PD Modification Application: PRS 22-0822

BOCC Land Use Meeting Date: June 7, 2022

1.0 APPLICATION SUMMARY

AGENCY REVIEW COMMENT SHEET

2.5 Proposed Site Plan (partial provided below for size and orientation purposes. See Section 8.2 for full site plan)

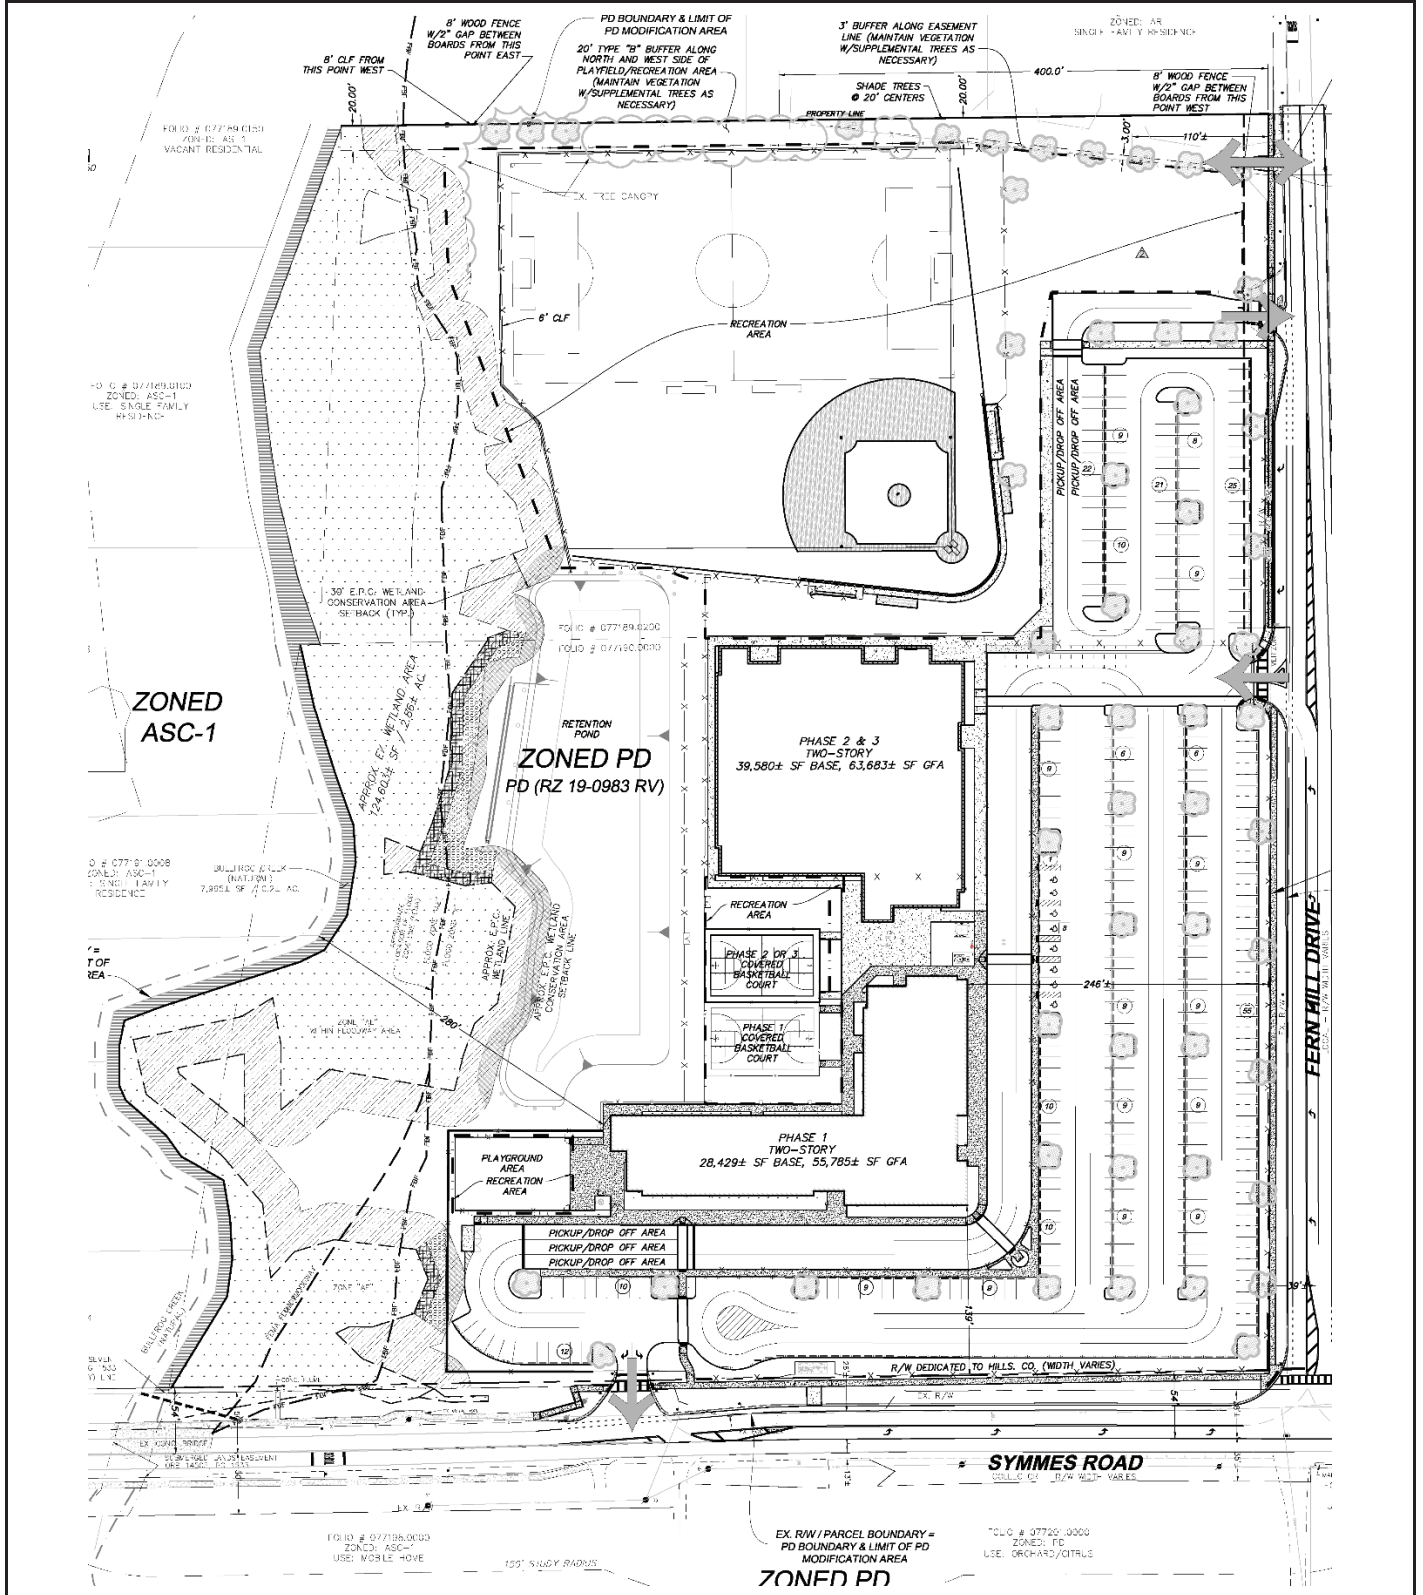
Staff finds the revised development configuration compatible with the surrounding development pattern. The proposed modifications will reduce the number of students and as a result create less of an impact on the surrounding uses.

8.2 Proposed Site Plan (Full)

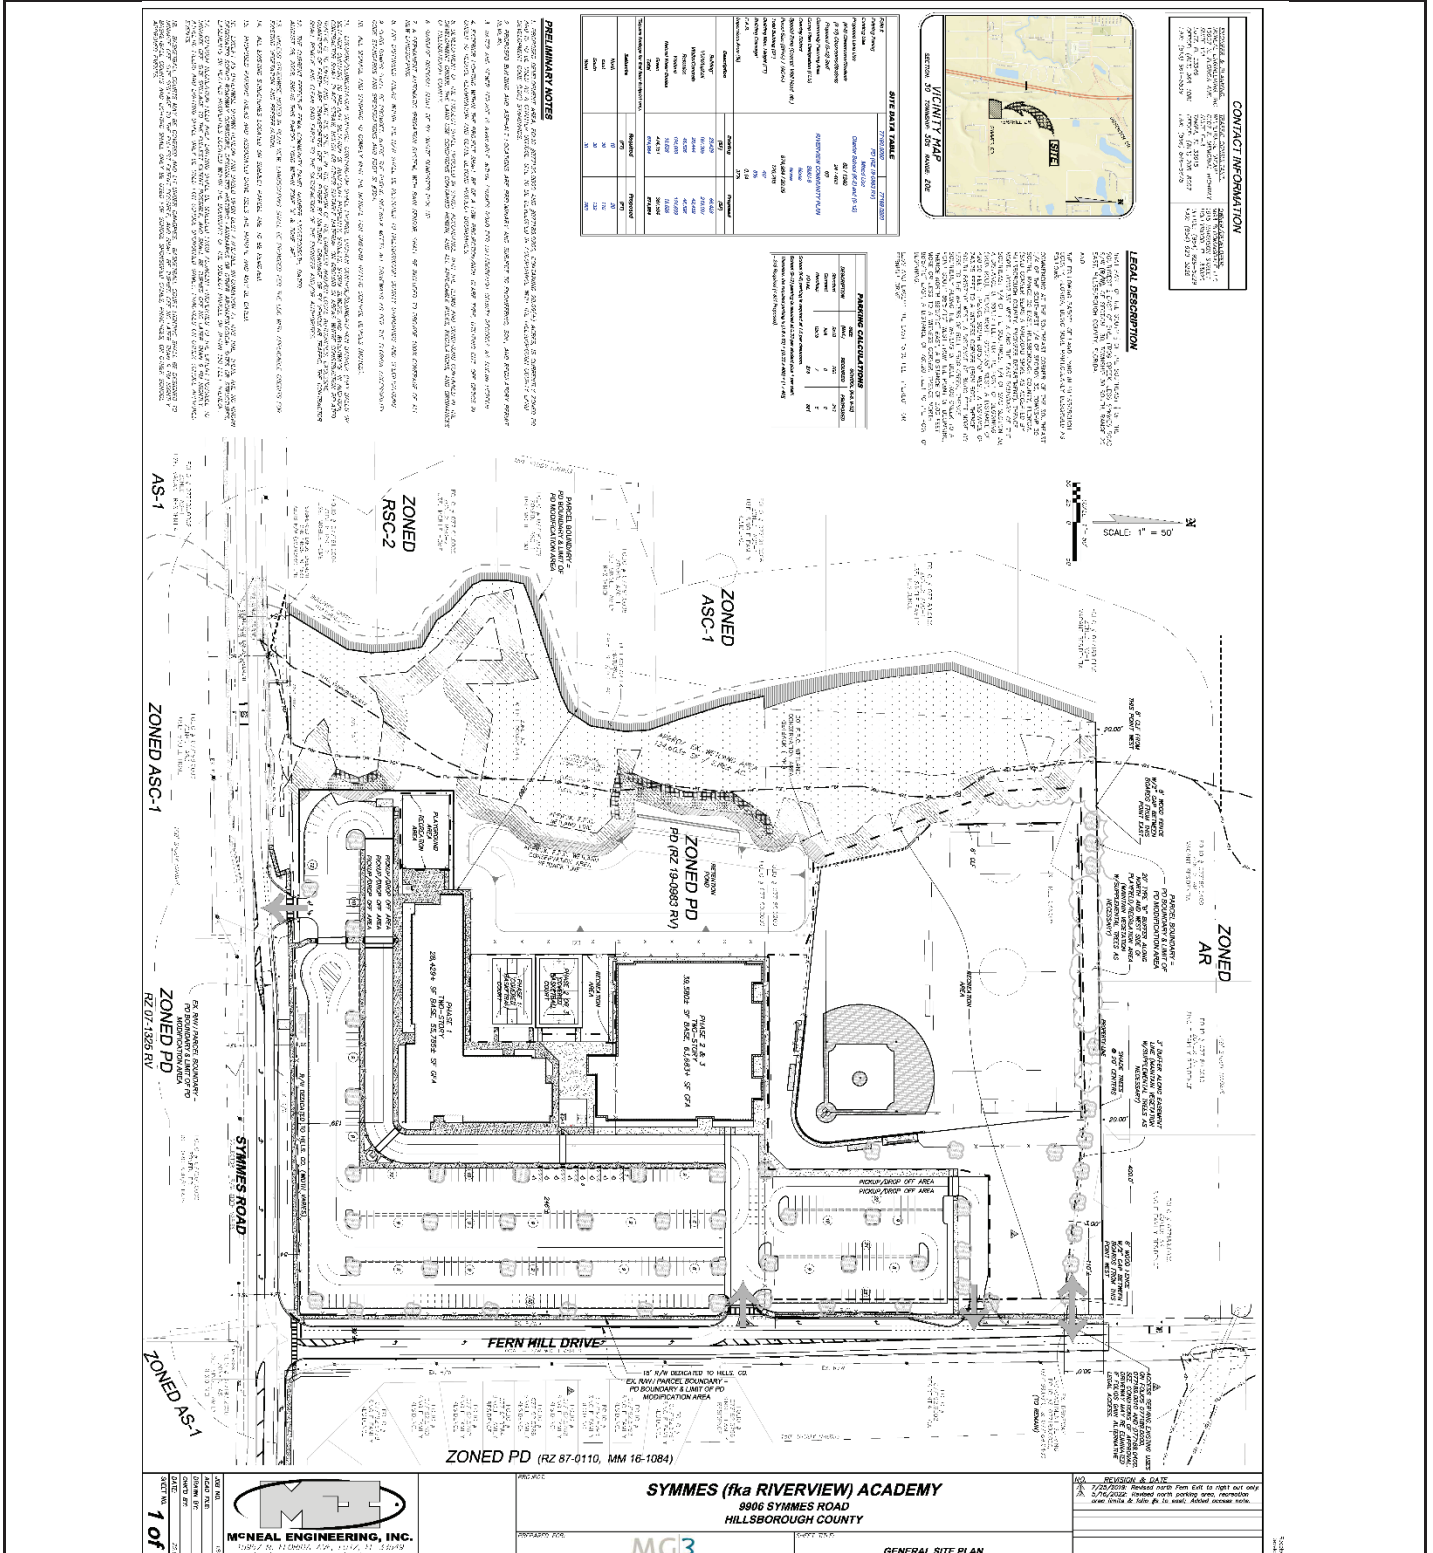
Prior to certification, the general development plan must be revised with the boundary line of the PRS removed.

Staff has reviewed the applicant’s proposed plans and find the circulation and queuing and event parking plans comply with Hillsborough County LDC Section 6.03.13 requirements governing private and charter schools. The reduced queuing provided (as compared to the existing approved plan), is offset by the reduction maximum capacity by 200 student stations.

Approval – Approval of the request, subject to the conditions listed, is based on the revised general site plan submitted April 25, 2022.
